**STATE OF NEW MEXICO  
BEFORE THE WATER QUALITY CONTROL COMMISSION**

**PETITION TO AMEND 20.6.4.126 NMAC AND  
20.6.4.141 NMAC TO ESTABLISH A SEGMENT-  
SPECIFIC TEMPERATURE CRITERION  
FOR A PORTION OF THE UPPER SANDIA  
CANYON ASSESSMENT UNIT**

**WQCC No. 24-65**

**PETITION FOR RULEMAKING TO AMEND 20.6.4.126 AND 20.6.4.141 NMAC  
TO ESTABLISH A SEGMENT-SPECIFIC TEMPERATURE CRITERION  
FOR A PORTION OF THE UPPER SANDIA CANYON ASSESSMENT UNIT**

**Figure 3. Water temperature in Upper Sandia Canyon AU, 2014 to 2018**

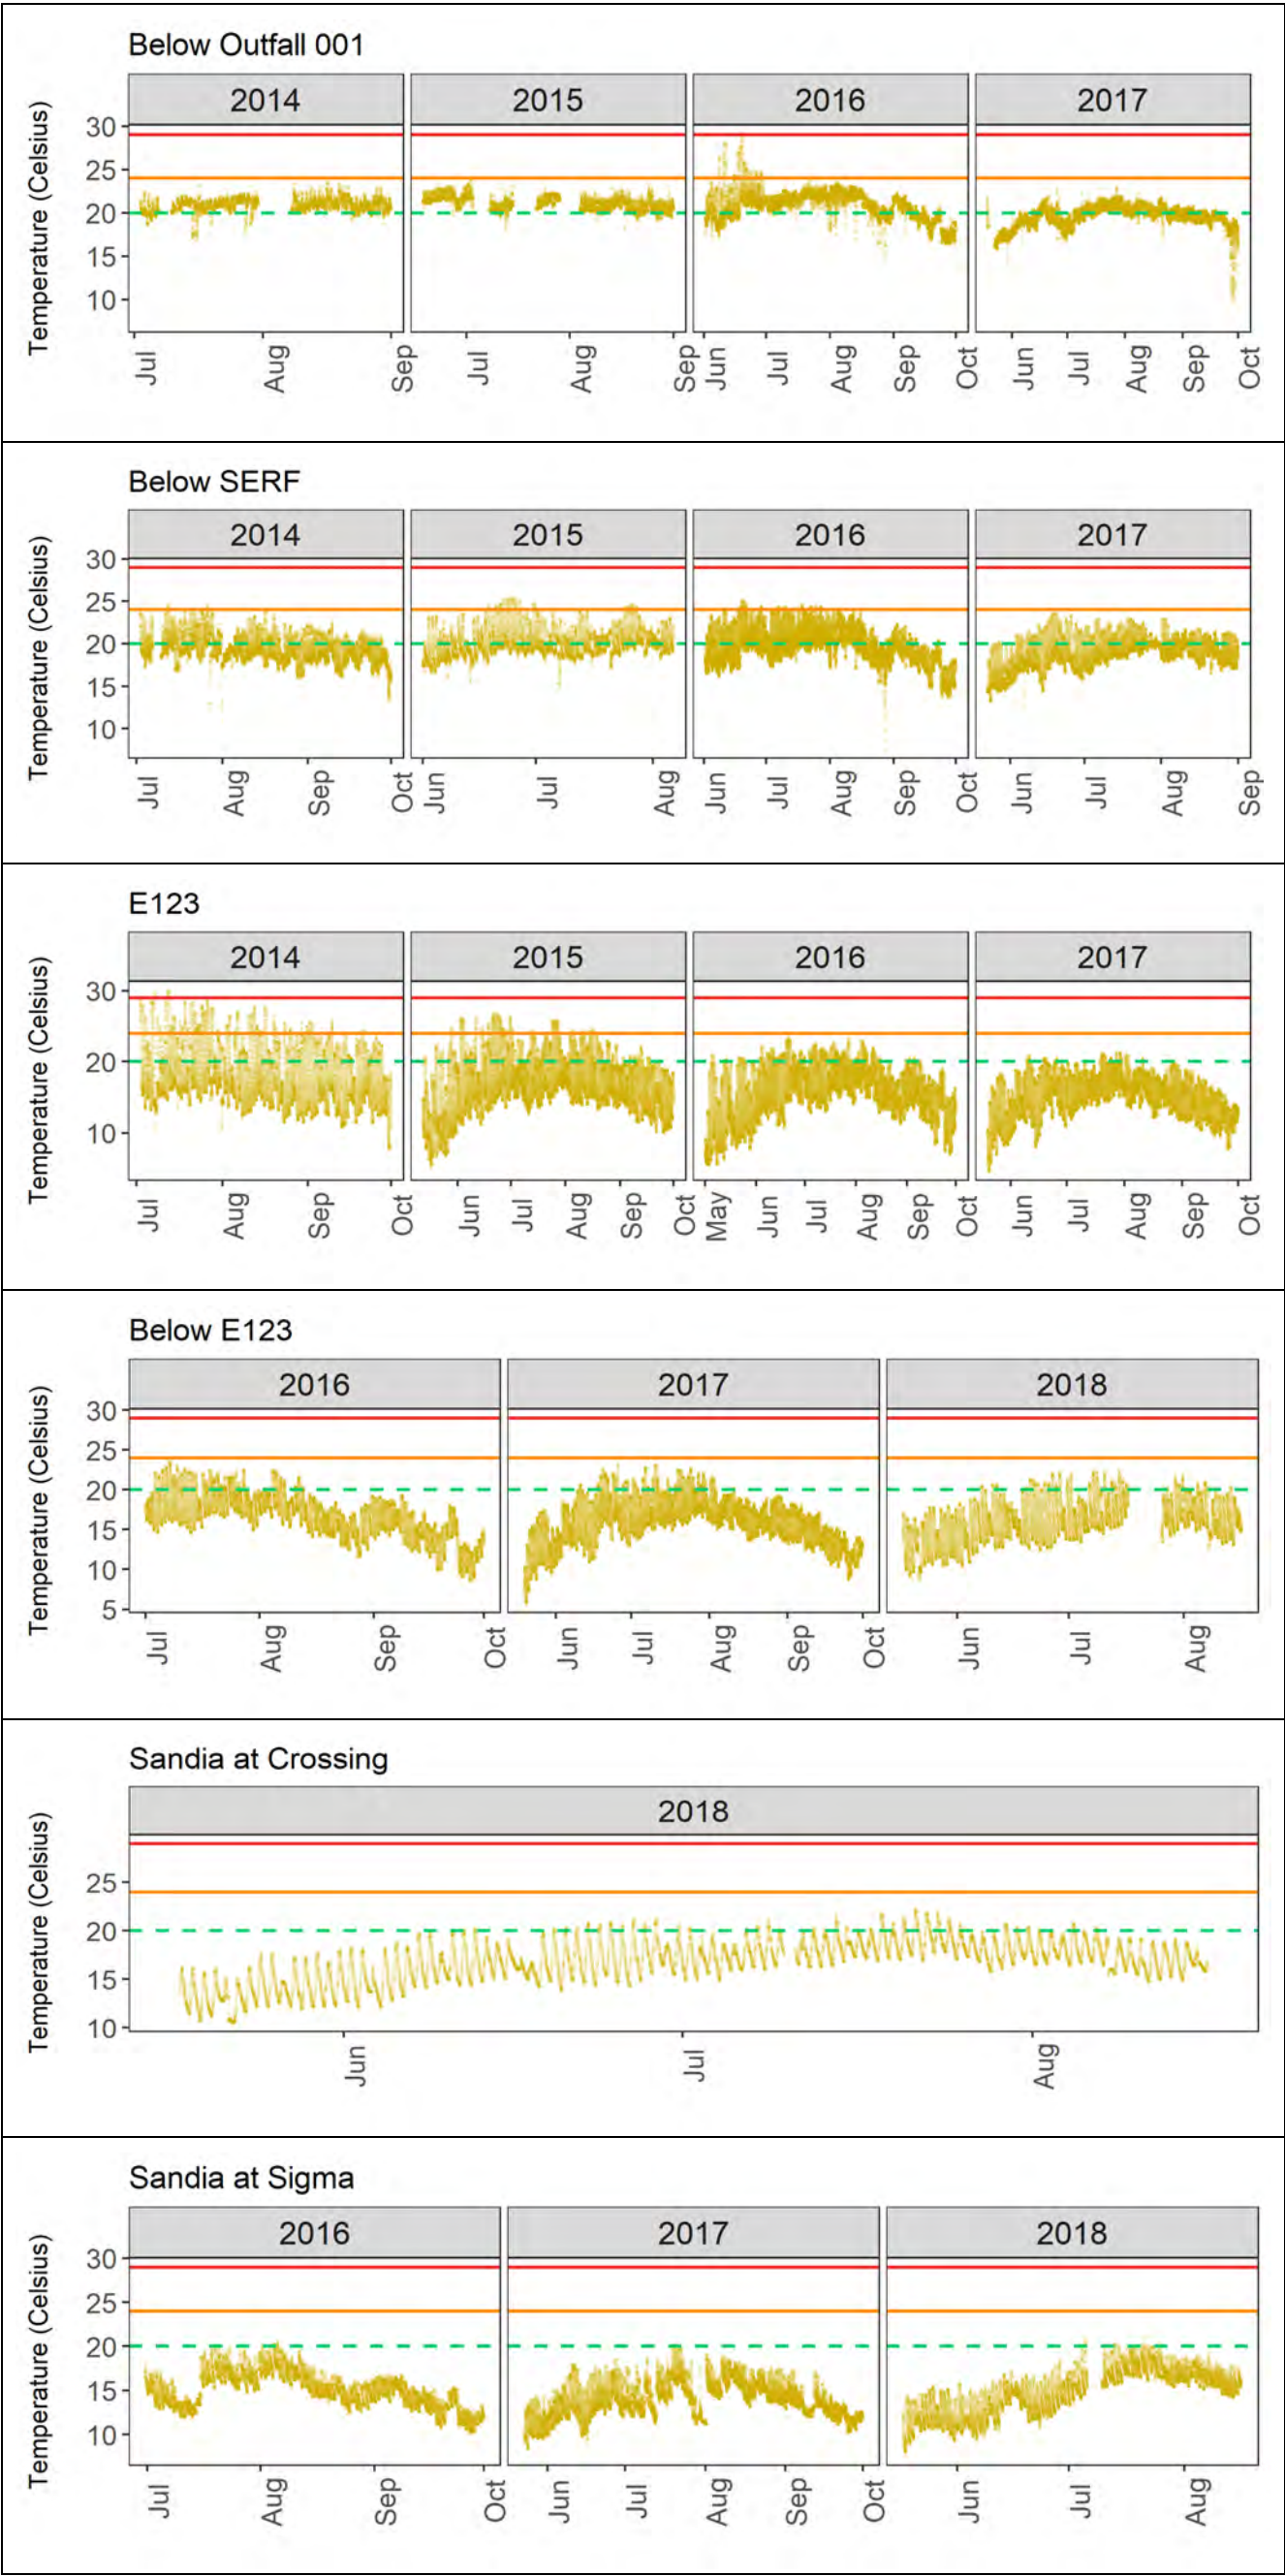
1. The model employed by LANL does not reflect the on the ground conditions and therefore should not be utilized as a basis for downgrading the standard. Specifically, the model employed by LANL predicts that the coolwater aquatic life use is appropriate for the upper portion (above E123.6) and that a warmwater aquatic life use is appropriate for the lower portion of the Upper Sandia AU between E123.6 and 123.8 (See Table 4) yet the actual water temperature data that was collected at the six thermograph stations show cooler temperatures in the lower portions of the Upper Sandia AU (See Figure 3).

Thermograph data, which represents "on the ground conditions," will be more strongly emphasized in the updated UAA. The assessment unit is not homogenous, and water temperatures are cooler downstream. These changes may be due to the natural geology of the reach and/or the grade control structure (Figure 1) that has generated enhanced wetland plant establishment (shading). The thermograph data collected for the UAA support a coolwater segment for upper Sandia Canyon (Table 1). However, the attainable use when the canyon becomes more incised and shaded is the current coldwater aquatic life use (ALU). To accurately reflect the thermograph data for the upper portion of the AU, DOE-Triad propose a new coolwater segment for Sandia Canyon at Bedrock Road (formerly at "Crossing") to Outfall 001. Additional protection for this segment will be provided by including a segment-specific 6T3 criterion of 25 °C (see Figure 2). DOE-Triad recognizes that cooler temperatures are observed in the lower portions of the AU,

Figure 2. Upper Sandia Canyon Assessment Unit Study Area.

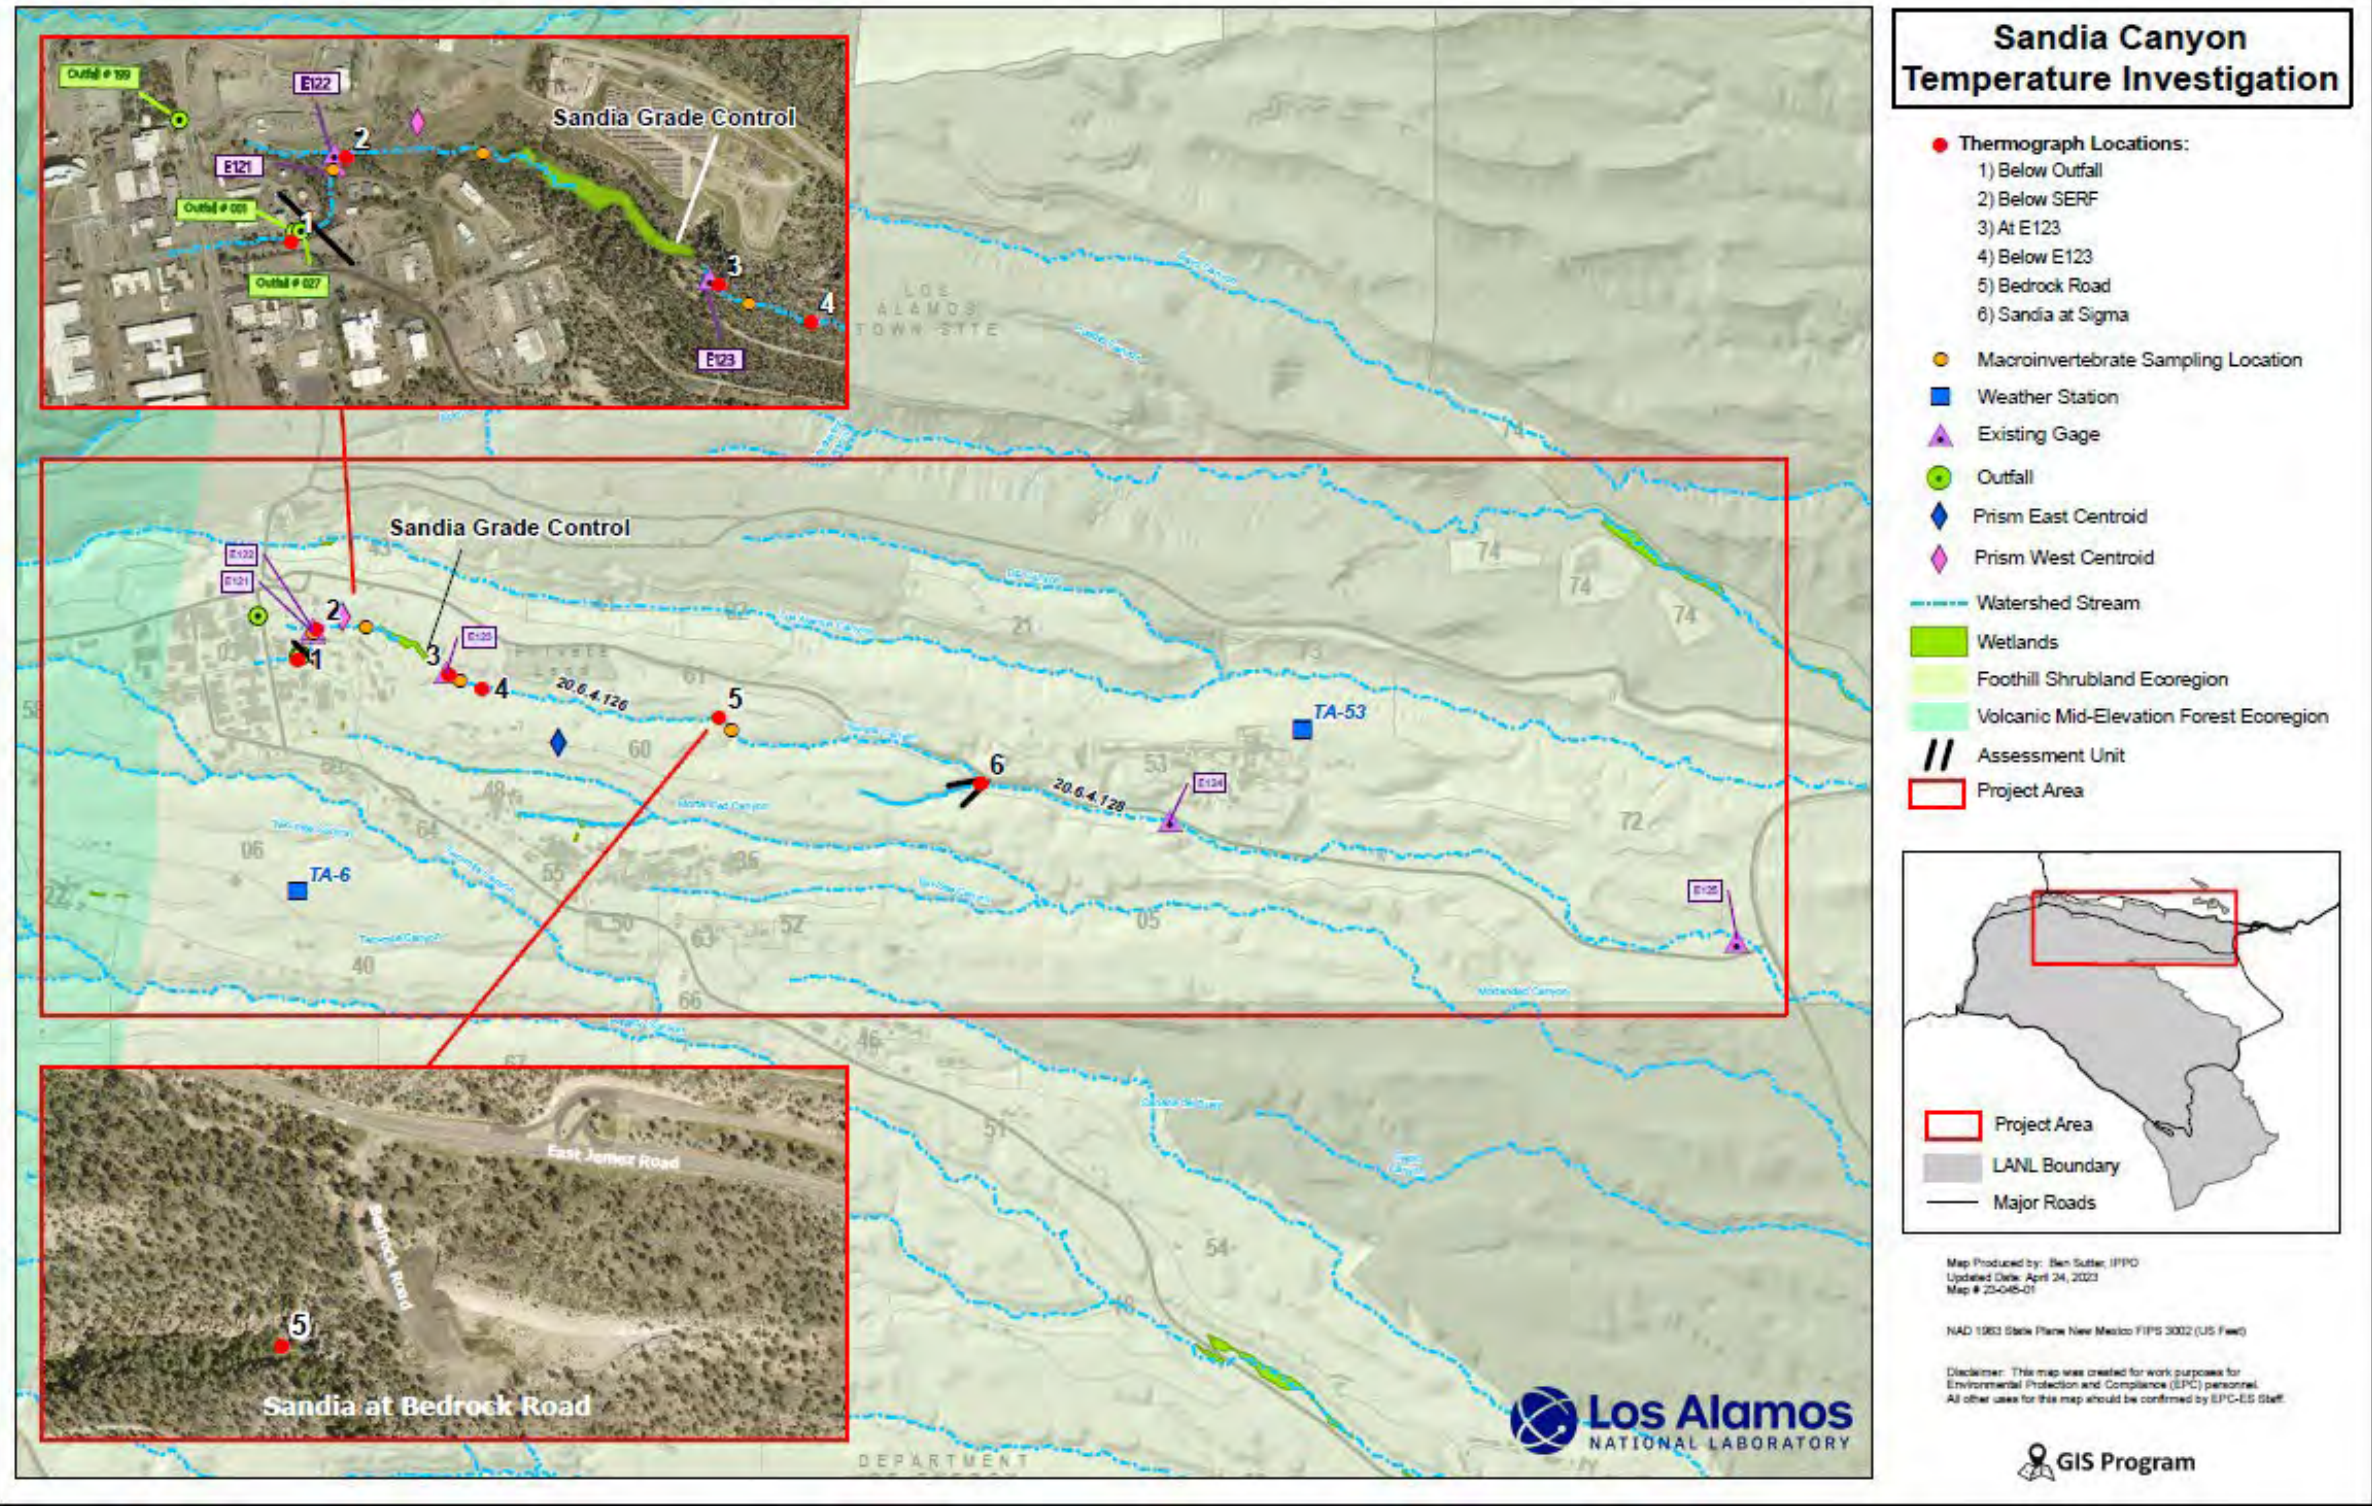
8. The Department requests the map with sampling locations (Figure 2) include the centroids for the two 800-meter Parameter-elevation Relationships of Independent Slopes Model (“PRISM”) cells (i.e., Upper Sandia AU-east and -west) used in the AWTC model.

The map with sampling locations (Figure 2) has been updated to show the centroids for the two Parameter-elevation Relationships of Independent Slopes Model (“PRISM”) cells (i.e., Upper Sandia AU-east and -west) used in the AWTC model. These centroids are located at the following coordinates:
